PROJECT BRIEF

Historic District Board of Review Application for Certificate of Appropriateness at 513 West St. to remove a side door and replace with a window.

HDBR Meeting Date: January 22, 2024

513 West. St — Top Unit

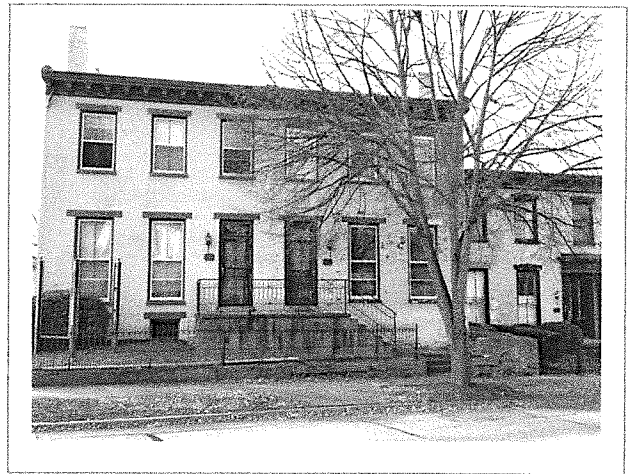
The project *is not in* conformance with guidelines. Staff does not believe the doorway is original as Sanborn maps show multiple variations of rear additions on the structure; however, the proposed vinyl window is not appropriate; *is not in* conformance with the Ordinance because the proposed materials is not visually compatible with the existing structure; and is *not* in conformance with SOI for Rehabilitation because the proposed alterations involve more than minimal exterior visual change.
